AM 2 Revised Application - for Submission by email - Cross Gold Mine - M-1977- 410

GIR 110(2) Amendment 2 – Revision 1.0
 DRMS Comment and Resolution Sheet - Page 1 of 25
 Grand Island Resources, LLC. Responses

Project: CROSS AND CARIBOU MINE - AM 2 APPLICATION	Project No.: 21-1306	MAP 01
Location: NEDERLAND, COLORADO, USA	Date: NOV. 2021

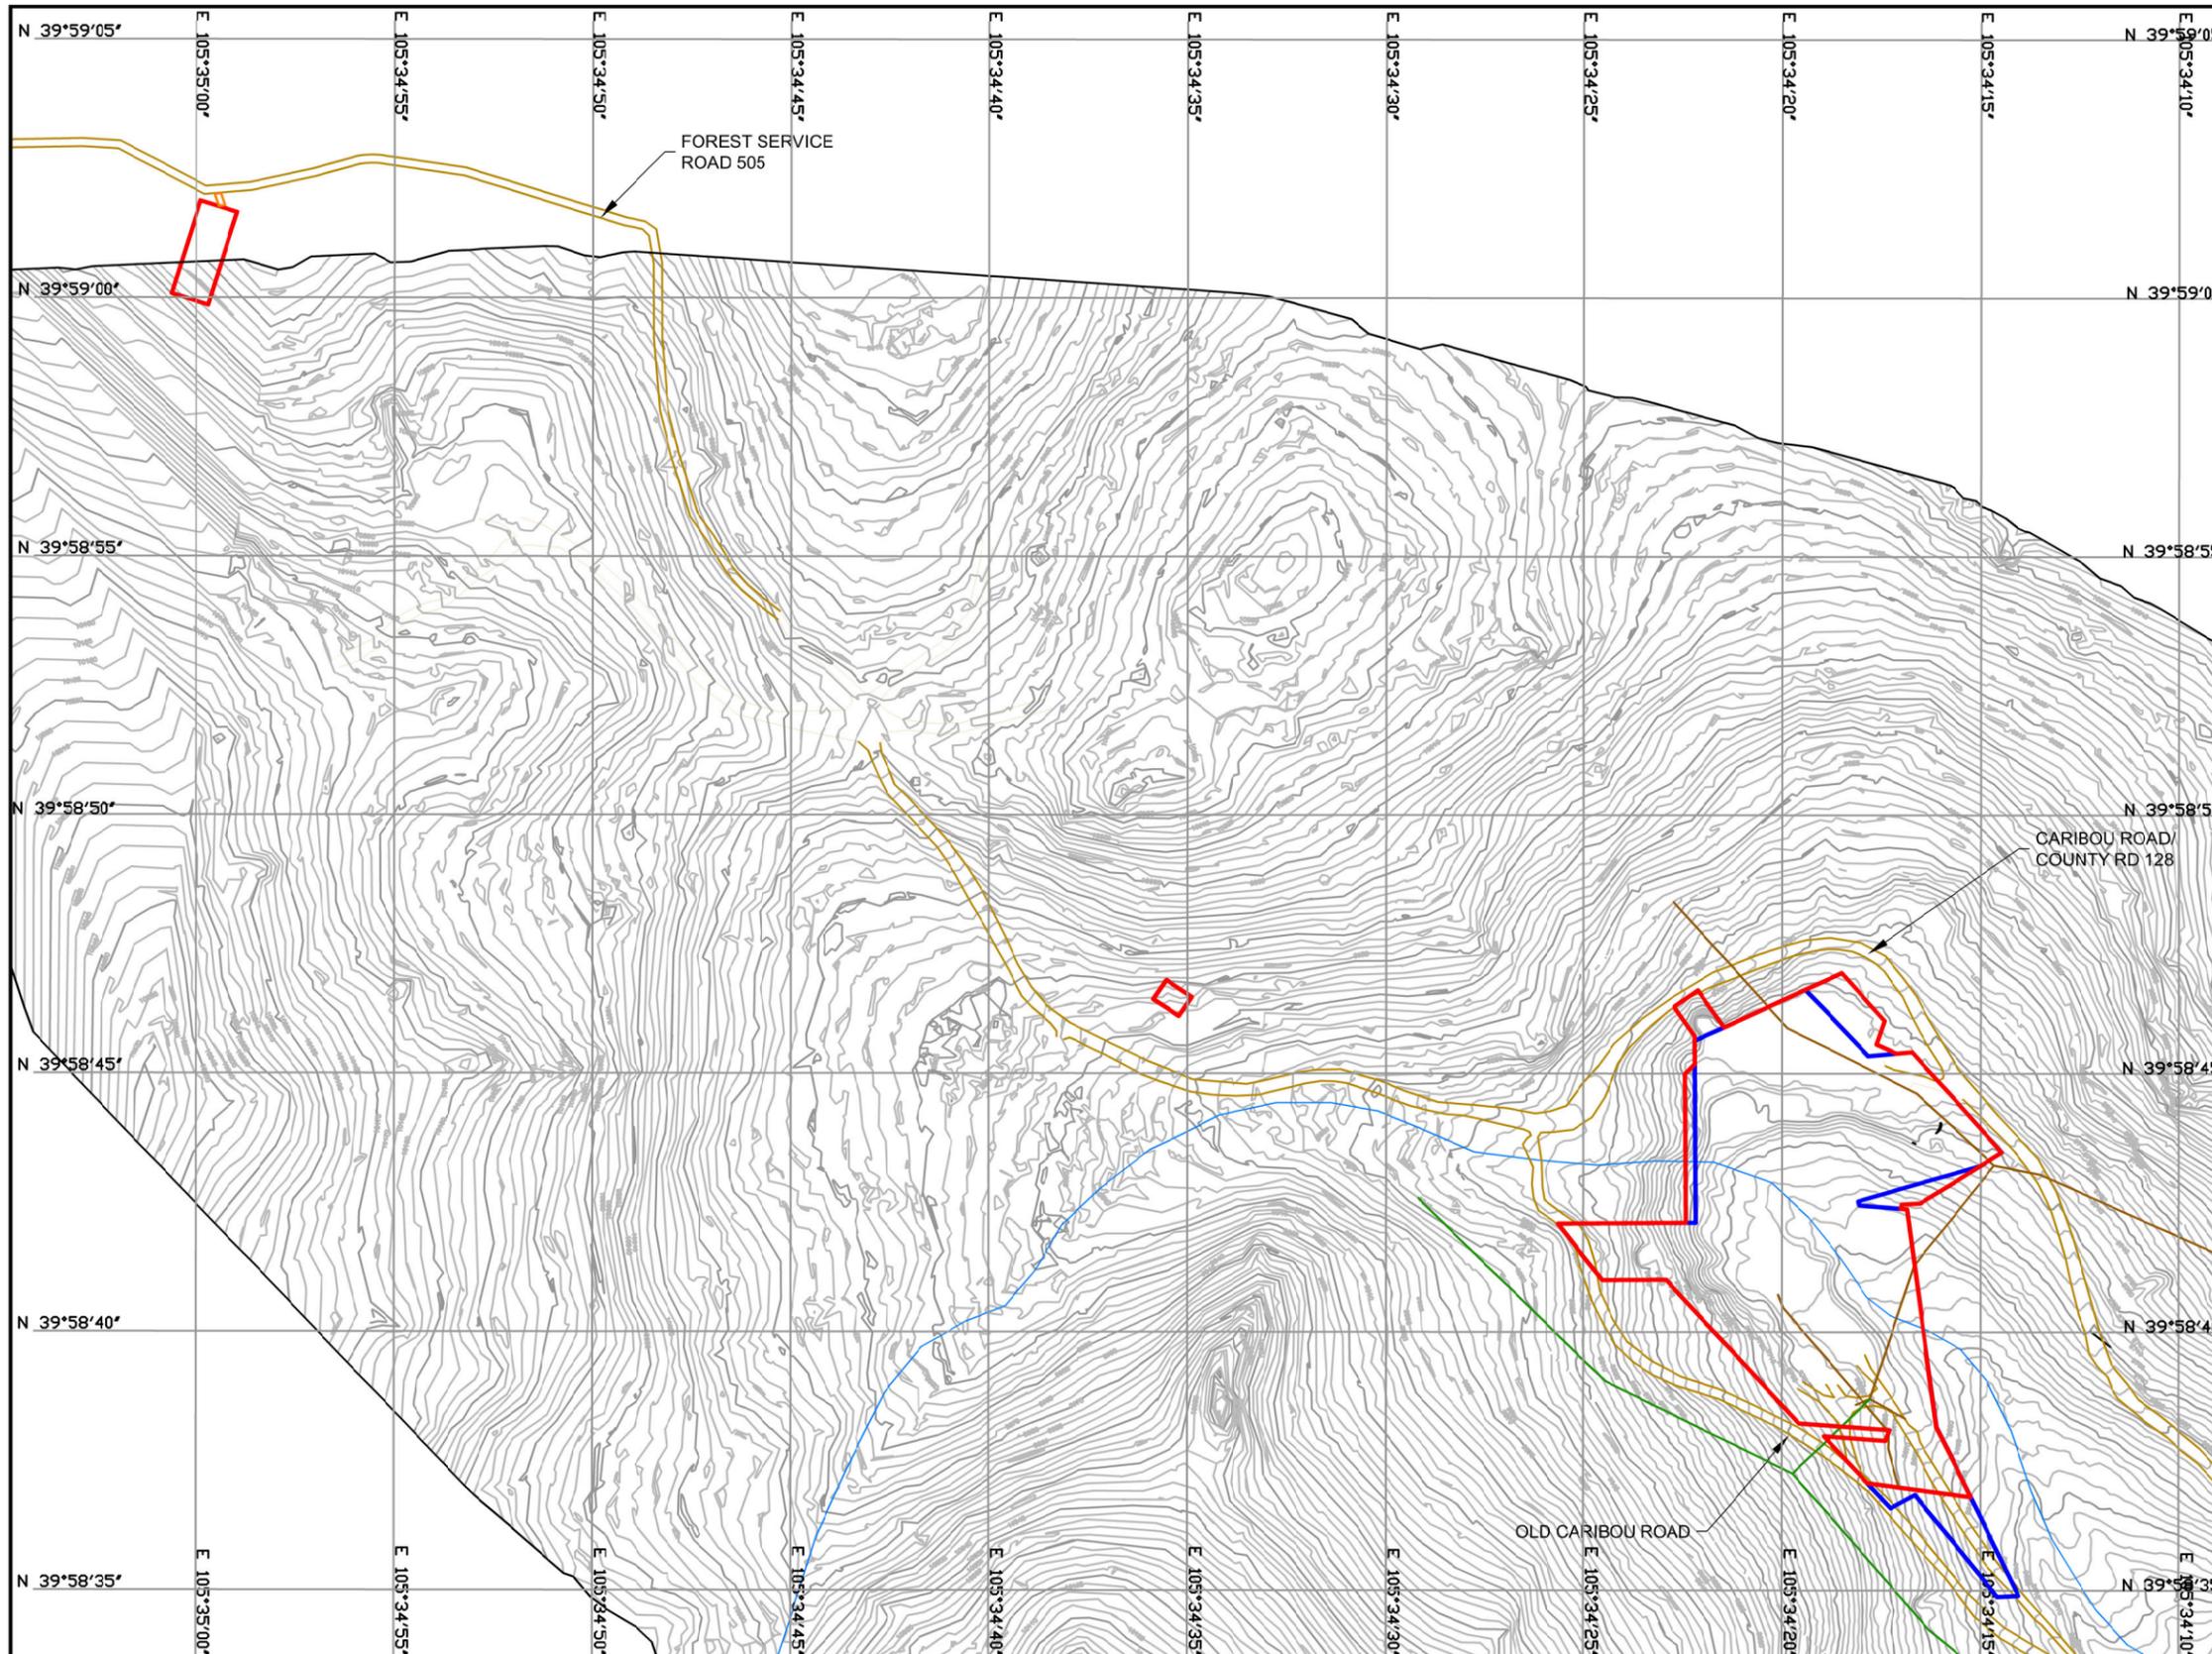
40	11	<p>Exhibit E – Maps (Rule 6.3.5)</p> <p>On Map 1, the locations of a Storage Magazine (#10) and an Old Stone Magazine (#28) are indicated. If these structures will be used by the operation in any way, please be sure to describe their anticipated use in Exhibit C. Additionally, this map shows several pipelines which convey water from the Cross and Caribou Mines to the ponds, from one pond to another, and from the ponds to the discharge location in Coon Track Creek. Please be sure to describe all water infrastructure in Exhibit C and provide a plan for reclaiming this infrastructure in Exhibit D (e.g., removal of above ground portions, removal of any buried portions, disposal). Costs for removing and disposing of any water infrastructure should be included in the reclamation cost estimate provided in Exhibit D.</p>	<p>Historic structures are noted in Exhibit C, Section 1.7.</p> <p>Water structures are described in Exhibit C, Section 1.3 and Exhibit D, Section 1.5. Costs are included in Appendix III.</p>

Project: CROSS AND CARIBOU MINE - AM 2 APPLICATION	Project No.: 21-1306	MAP 04
Location: NEDERLAND, COLORADO, USA	Date: NOV. 2021

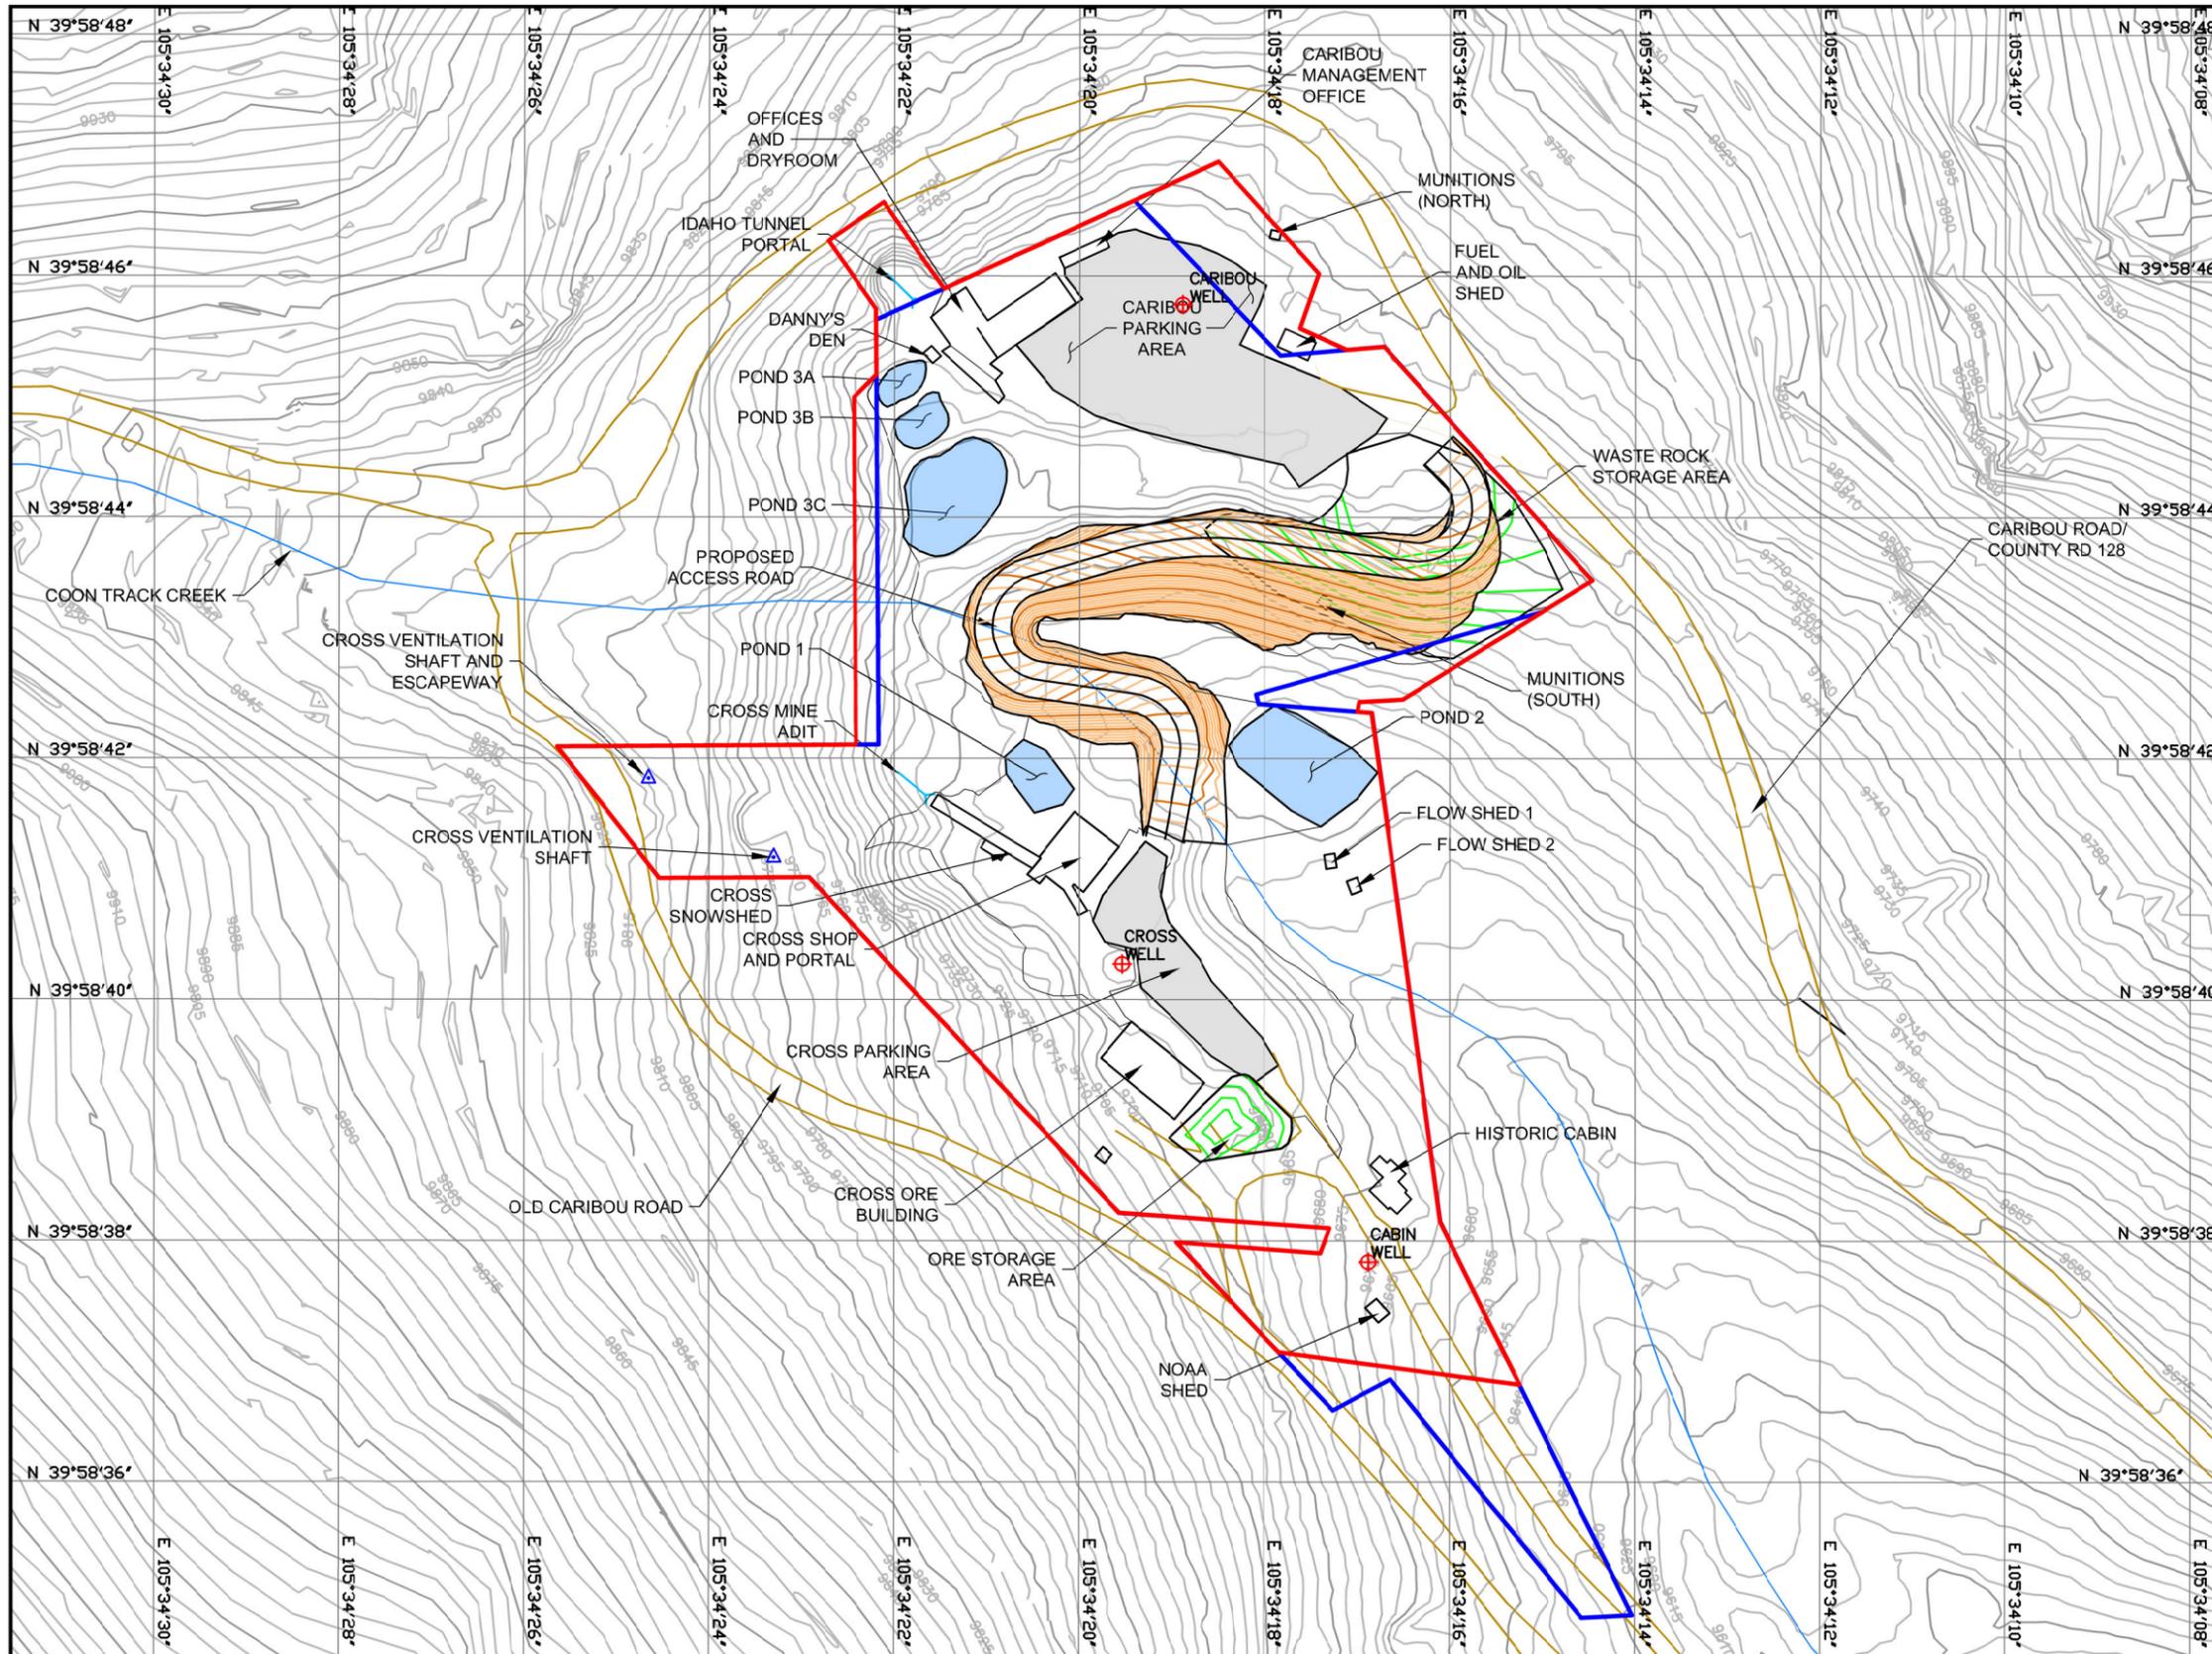
#	Page/ Line	Comment	Where Addressed (Exhibit, Attachment, Appendix)
		On Map 4, please label the access roads and any other structures located on or within 200 feet from the proposed permit area (e.g., snow shed, mine openings, historic structures, fencing), and identify the owner(s) of each structure. Additionally, please show the location of the new road to be constructed at the Caribou 300 Level Portal site. Finally, please label the landowner(s) of the affected lands and of the lands located within 200 feet of the affected lands.	Maps.
43	12	Exhibit E – Maps (Rule 6.3.5) On Maps 1, 2, and 4, the proposed permit area for the Caribou 300 Level Portal site is shown to partially overlap the access road to the north, which the Division believes is a U.S. Forest Service Road. If this is the case, then in Exhibit G, the operator will need to provide documentation of its legal right to enter any affected lands owned by the U.S. Forest Service.	This map has been corrected and is now shown as Map 3.
